Access Compliance Report

Public Rights-of-Way

(Pedestrian Signals)

Intersection ID: N/A	Main Street:	Cross Street: N/A	Location: N/A
ADA ID: 5557C8F1BA6F	Signal Type: One Push Button-Non APS	Overall Compliance: No	Severity Score: BTN 1: N/A BTN 2: N/A No BTN: N/A
Codes/Mitigation Info/Possible Solution		Field Measurements/Component Compliance

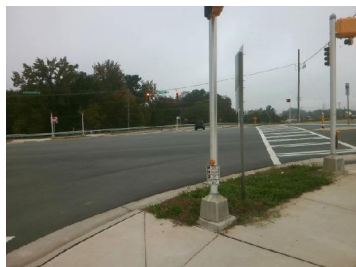
Possible Solutions: Provide Push Button Extension. Remove and Replace Clear Space.

PROW/ADA: R209.1, TMUTCD 4e.08, R404.2, R404.3, R406.2
